SUBJECT: Application for amend to Licenses DPR-58 & DPR-74, revising
 radiological effluent Tech Specs & "Offsite Dose Calculation
 Manual" to incorporate changes agreed upon in 820809
 conference call, per S Varga 820824 ltr.

September 17, 1982
AEP:NRC:0055F

Donald C. Cook Nuclear Plant Unit Nos. 1 and 2
Docket Nos. 50-315 and 50-316
License Nos. DPR-58 and DPR-74
RADIOLOGICAL EFFLUENT TECHNICAL SPECIFICATIONS
AND OFFSITE DOSE CALCULATION MANUAL

FIGURE 5.1-3
SITE BOUNDARY FOR GASEOUS AND LIQUID EFFLUENTS

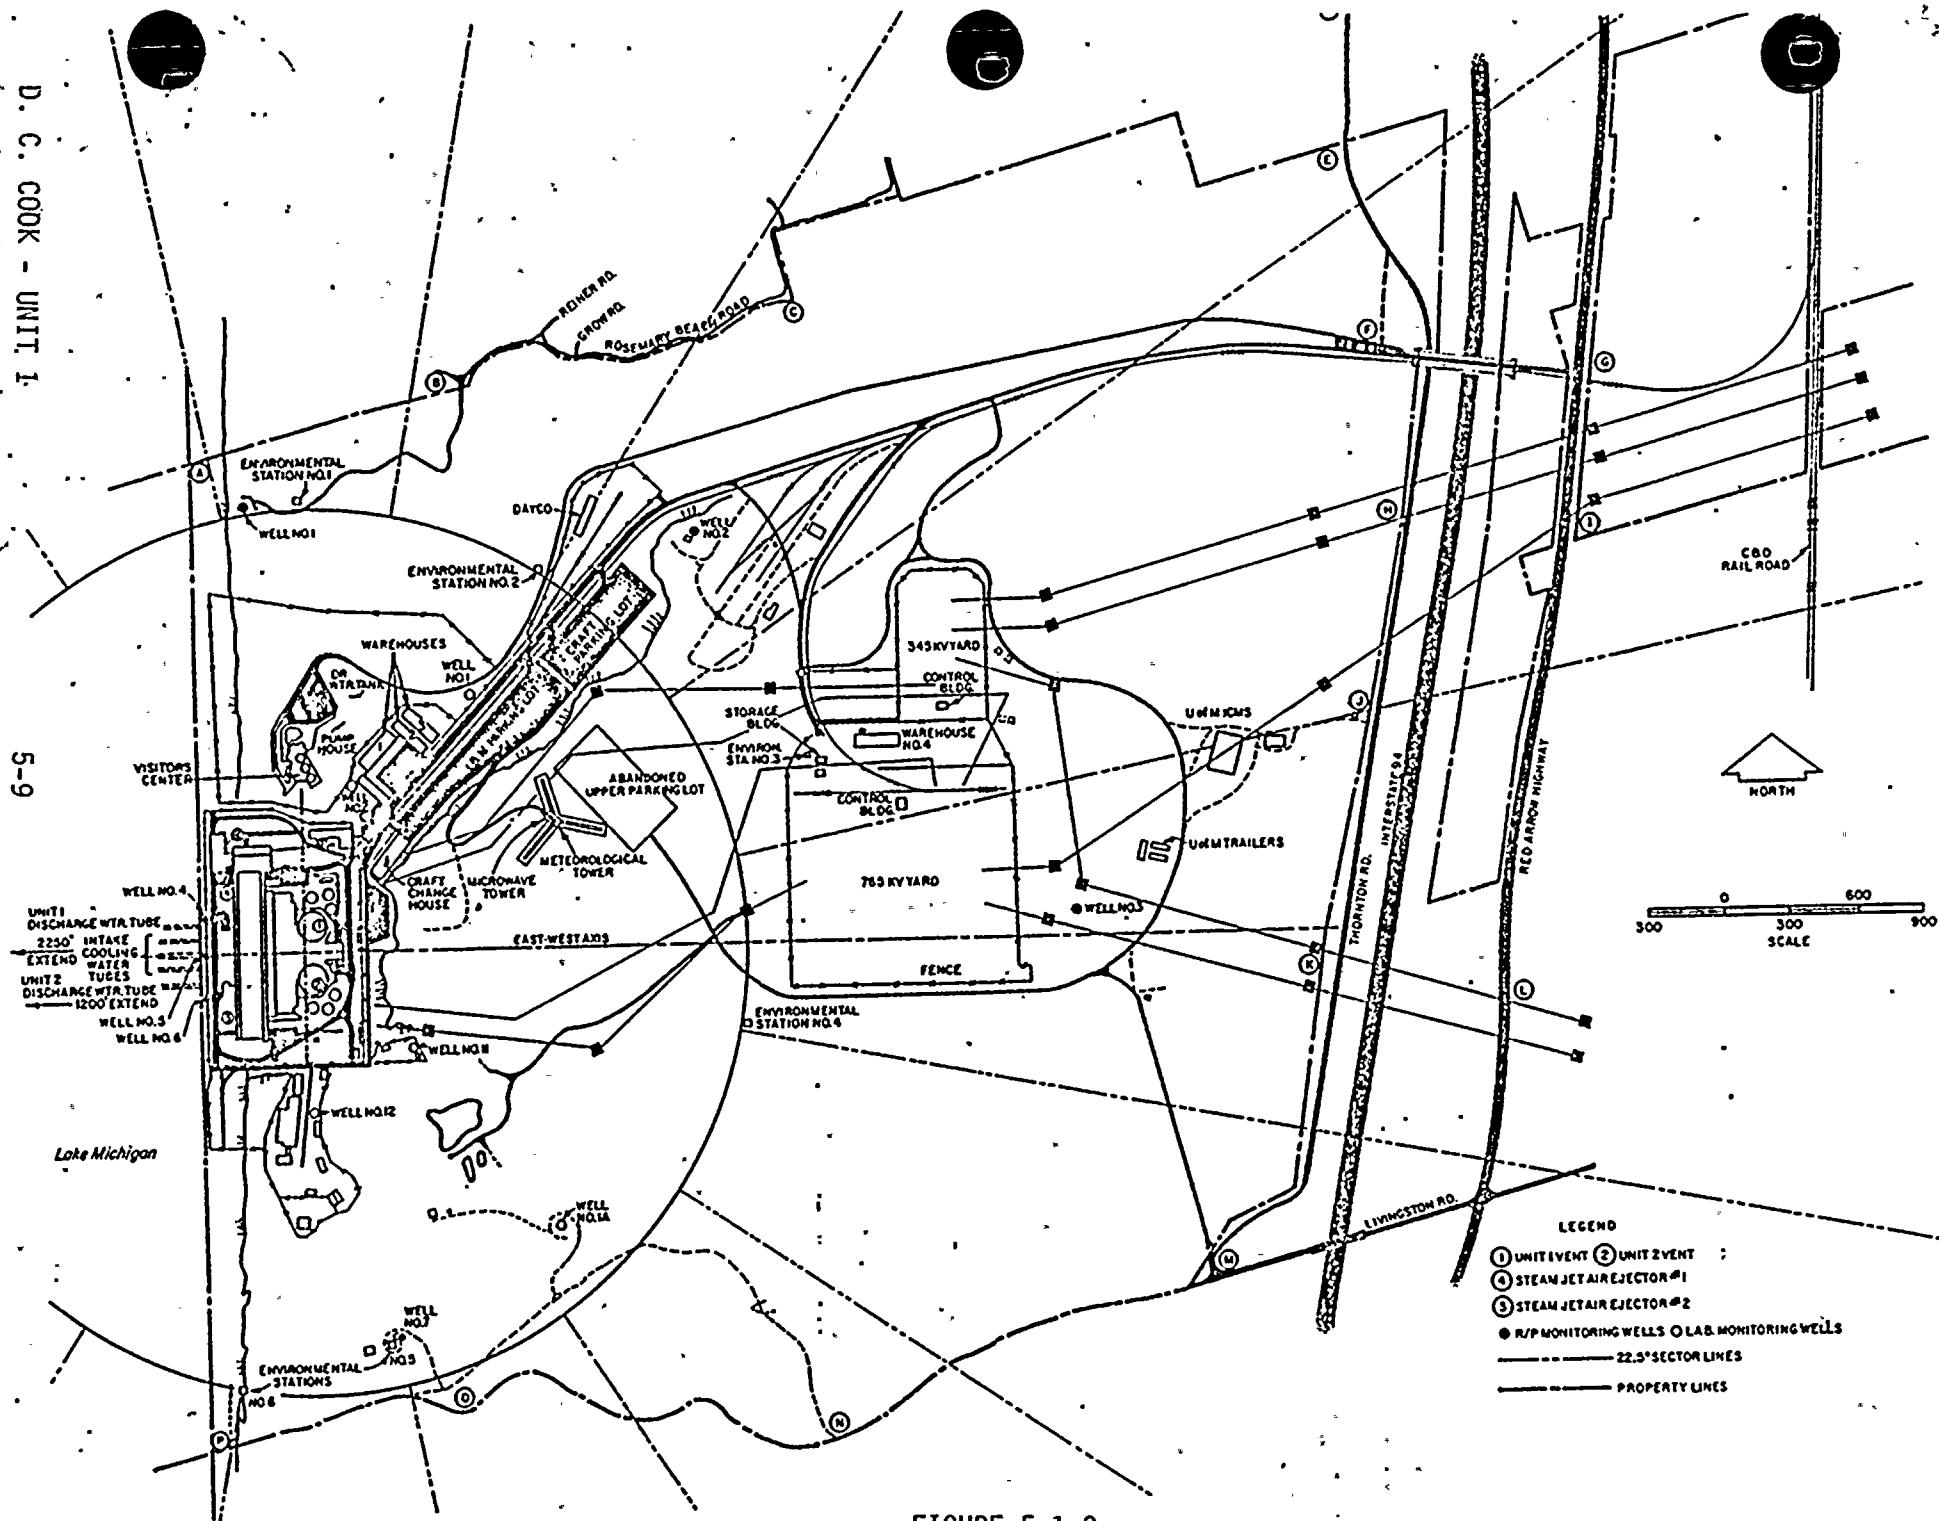
5.1.3 The site boundary for gaseous and liquid effluents shall be shown in Figure 5.1-3.

FIGURE 5.1-5
SITE BOUNDARY FOR GASEOUS AND LIQUID EFFLUENTS

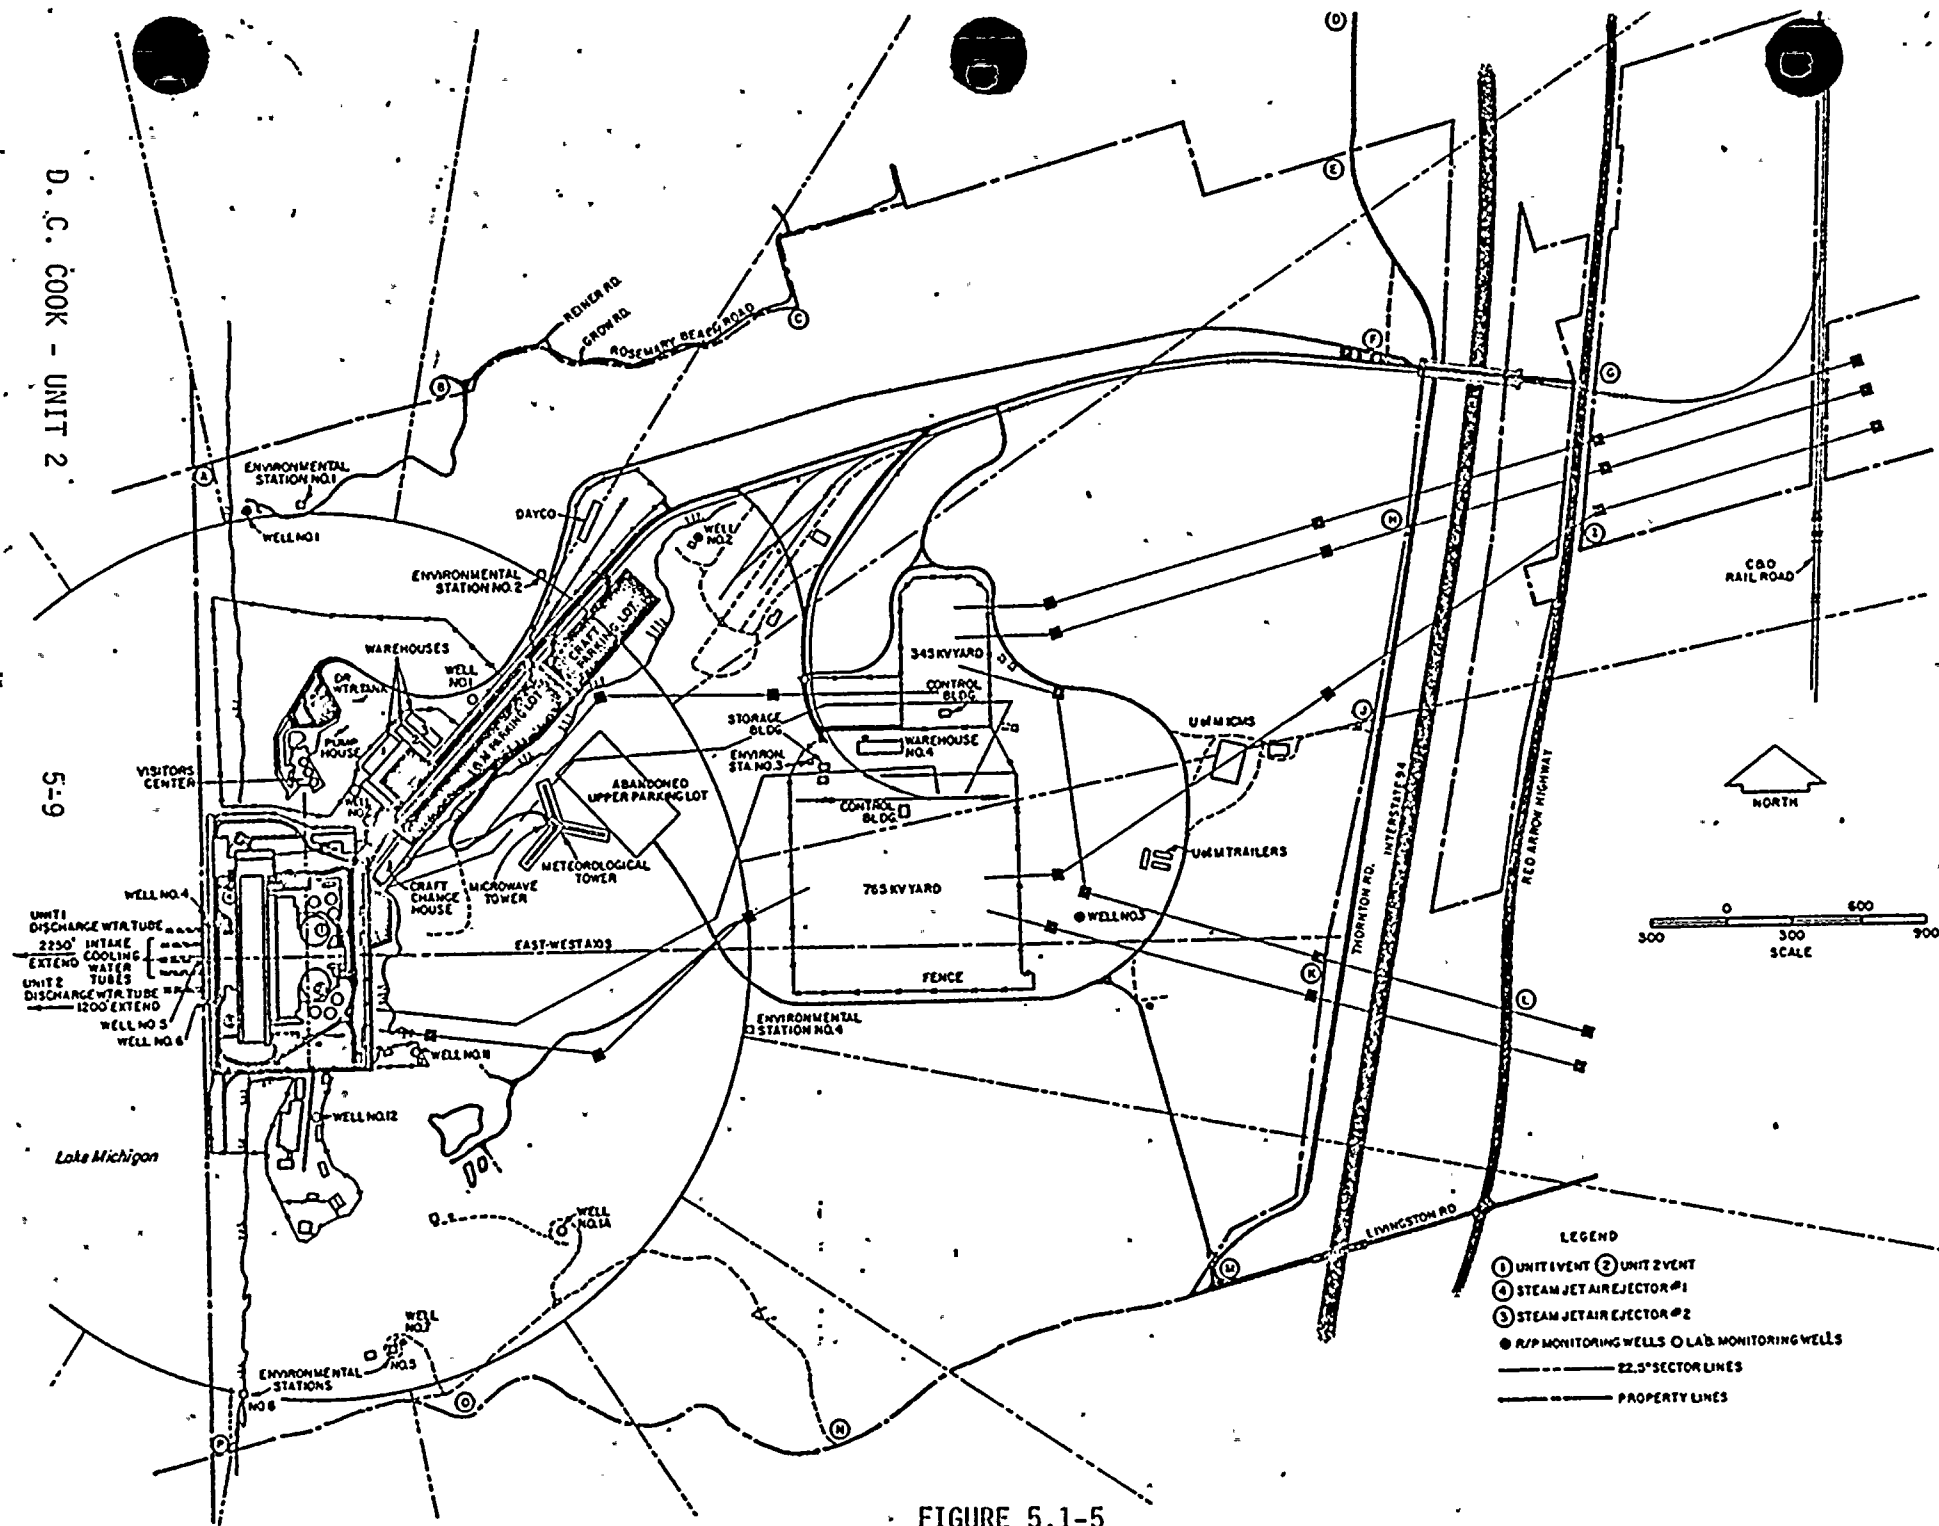
5.1.3 The site boundary for gaseous and liquid effluents shall be shown in Figure 5.1-3.
